UNLESS OTHERWISE NOTED LINEAR DIMS. IN INCHES. TOLERANCES DECIMAL .X+/- .XX+/- .XXX+/- FINISH √ ANGULAR +/- DO NOT SCALE DRAWING Drawing no.	T&T Pump Co. Inc. Fairmont,WV 26554	
	DRAWING TITLE	NH80T2F12 VS TONKAFLO SS12512E COMPARISON
DRAWN CWR 10-1-08	DWG SIZE A	CAD file NH80T2F12 VS TONKAFLO SS12512E COMP
CHECK	SCALE NONE	RELEASE DATE 10-1-08 Sheet 1 of 1
DESIGN		
ENGR

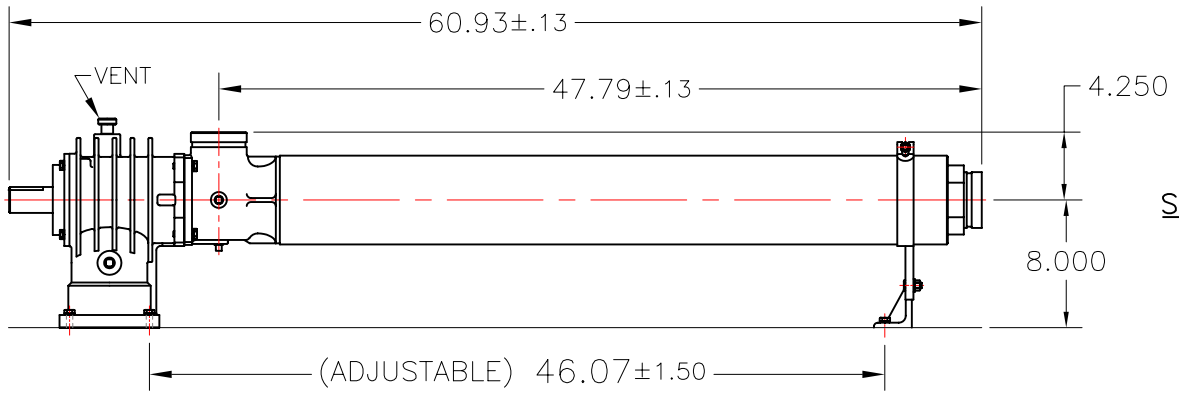
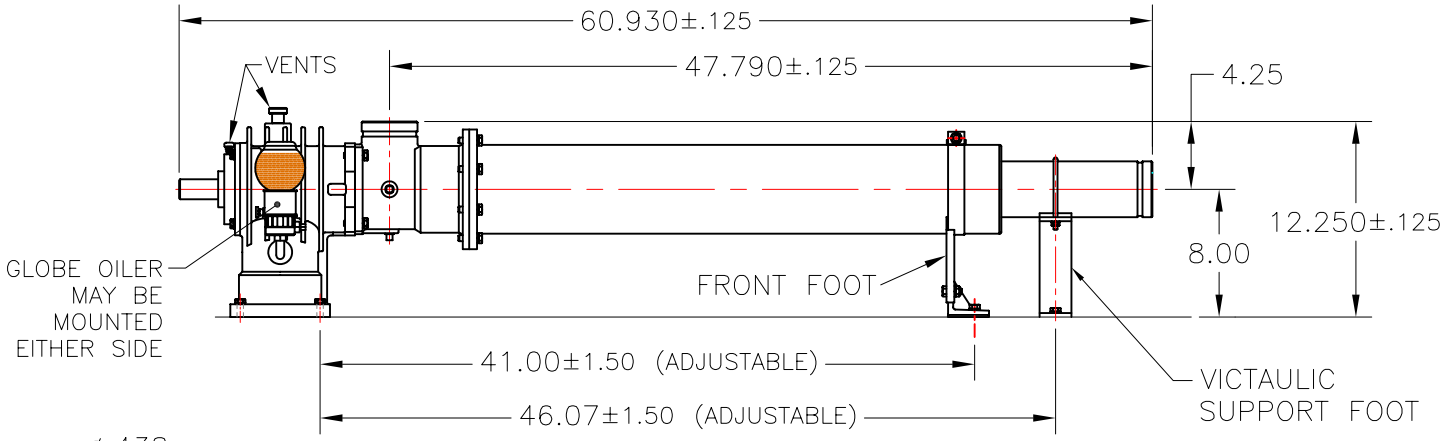
NOTES:
1. MODIFICATION WILL BE REQUIRED FOR THE FRONT FOOT MOUNTING HOLES.
2. BOTH PUMPS HAVE 12 STAGES.
3. BOTH PUMPS HAVE A 3" VICTAULIC INLET AND A 3" VICTAULIC DISCHARGE.
